Sunnyside Coal Company

Re: NOV92-32-17-1 Failure To Maintain Diversions

I have also revised Plate 5-5, A5-0110, to Plate 5-5, A5-0110-R, making the necessary changes. These are enclosed.

DRAWING NO. A5-0110-R

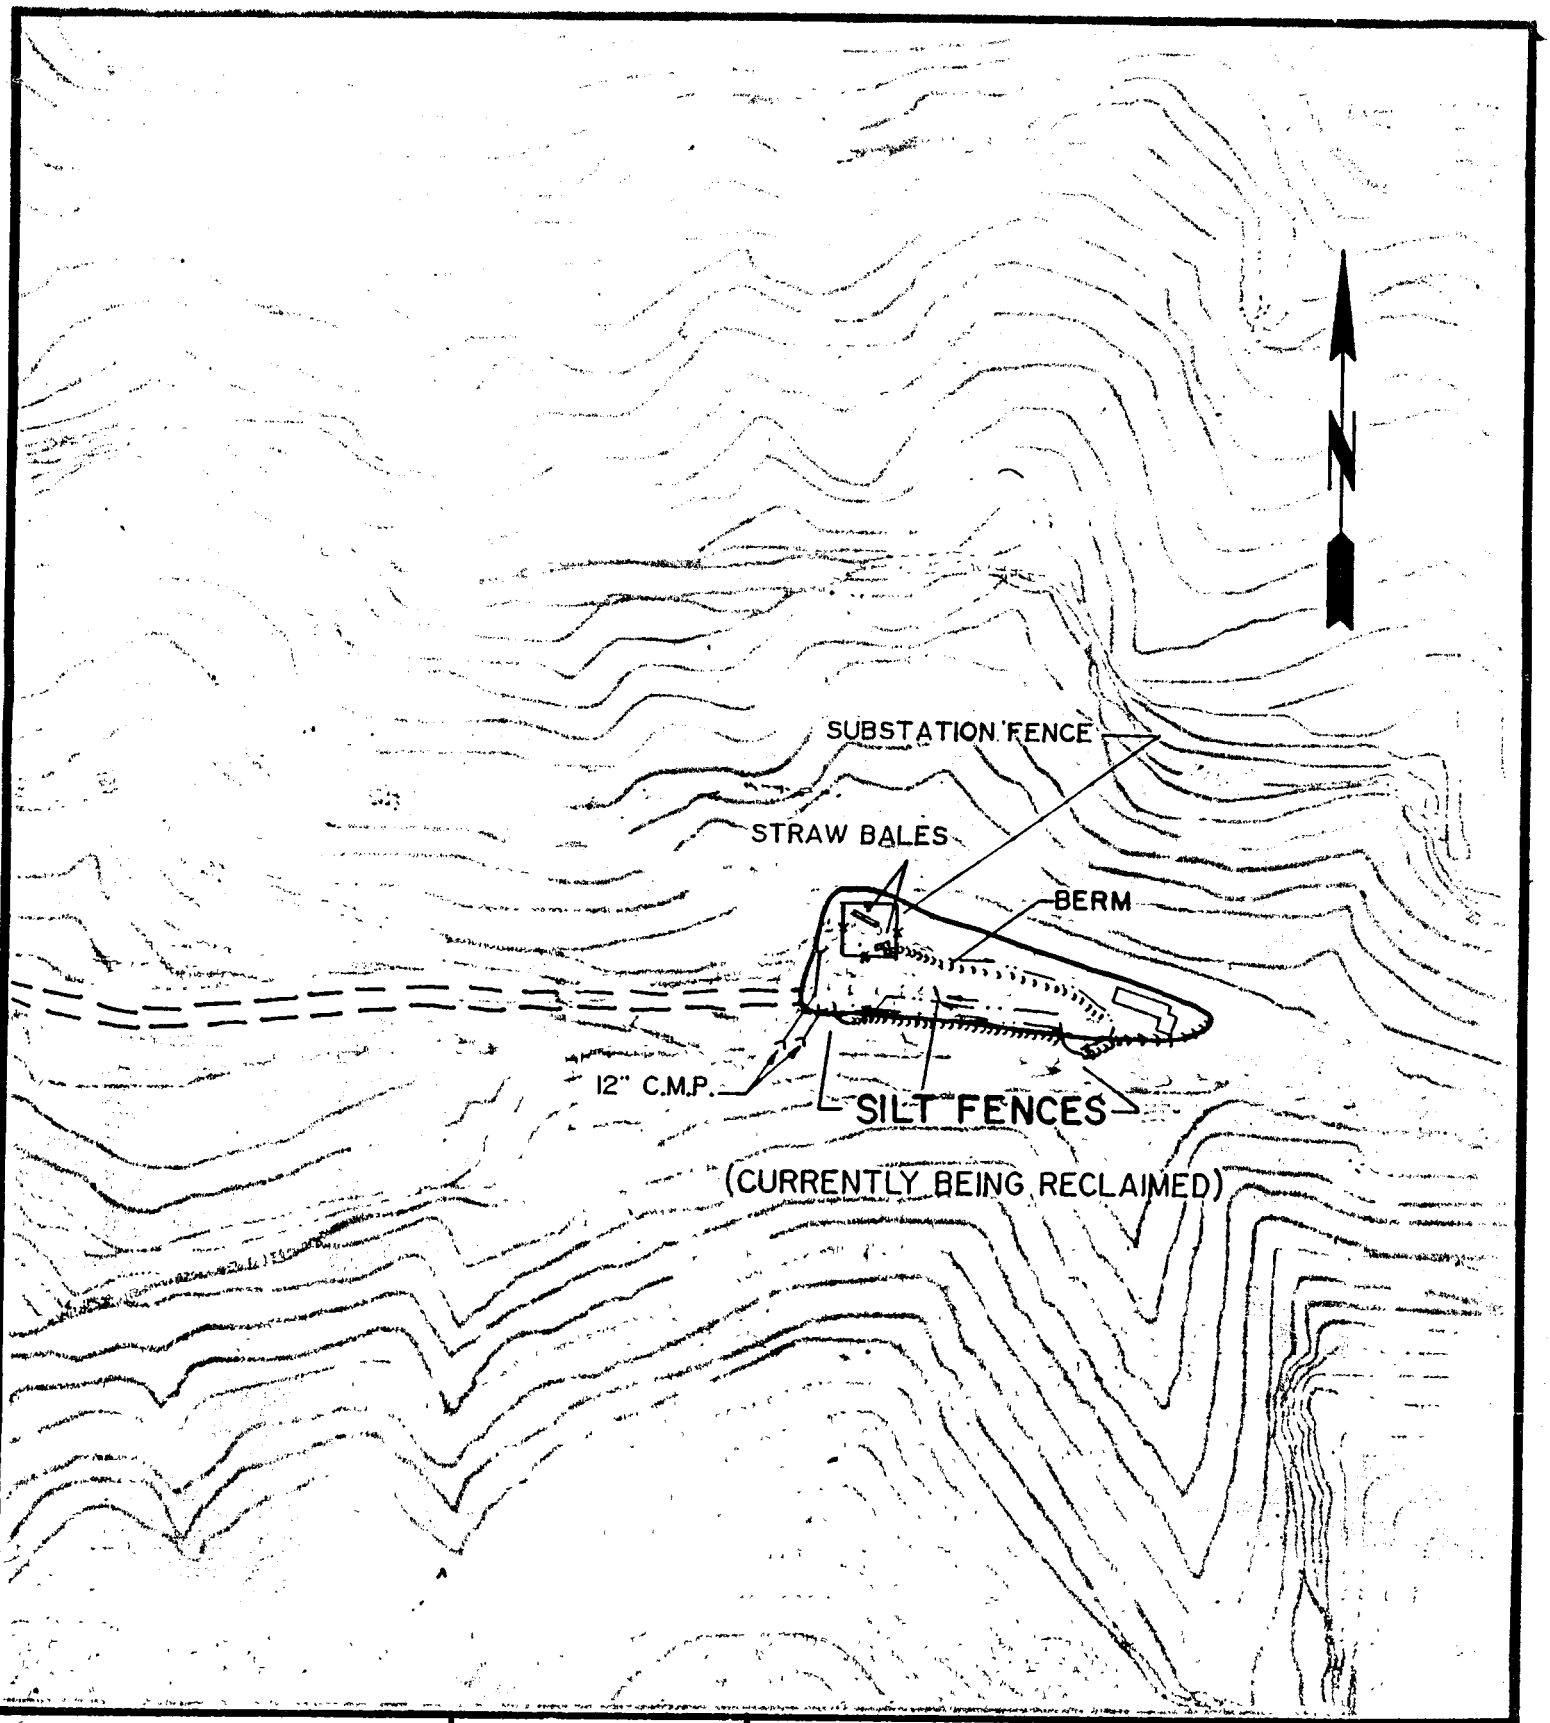
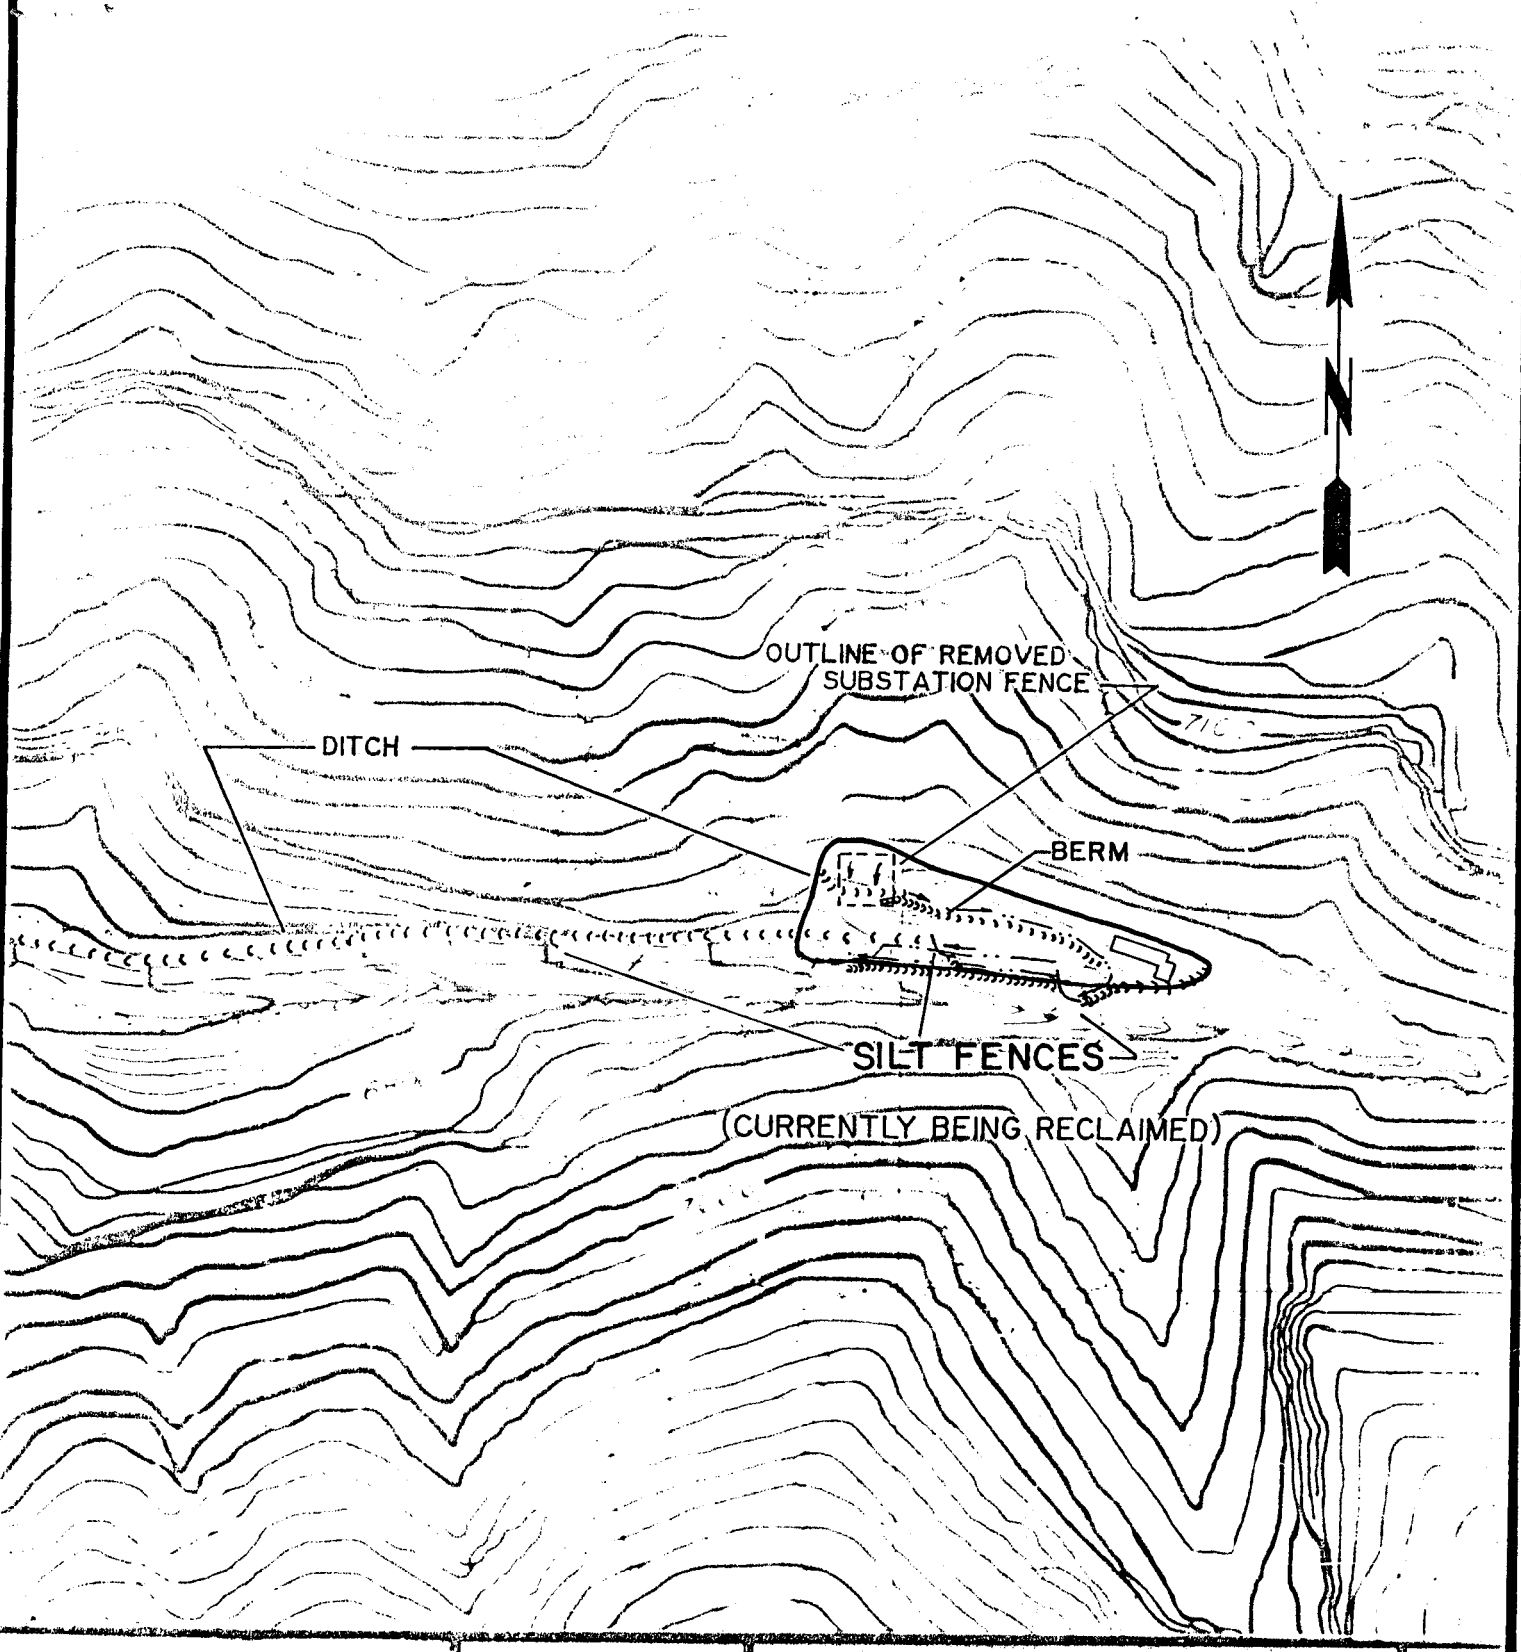
The abatement of the area at the Fan Canyon B.T.C.A. presents another problem. We used a backhoe to probe the area west of the old substation searching for the twelve-inch CMP inlet that supposedly drained the undisturbed area to the wash as shown on Plate 5-5, A5-0110. We had no success. The other twelve-inch CMP from the edge of the road to the wash was not located either.

Neither Ernest Monson nor Dale Andrews (who are long-time surface compliance personnel at this operation) remember either culvert. It is our belief that the culverts were never installed.

In order to provide temporary drainage for the disturbed area of the pad, Sunnyside Coal Company has removed two concrete pads inside the substation perimeter and cut a shallow ditch on an angle from the cliff wall on the west side of the old substation perimeter along the front of the pad and tied it into the berm which parallels the substation access road. All runoff would report to the silt fences below. We have also established a berm at the middle silt fence to the edge of the wash and redefined the ditch to the bottom fence.
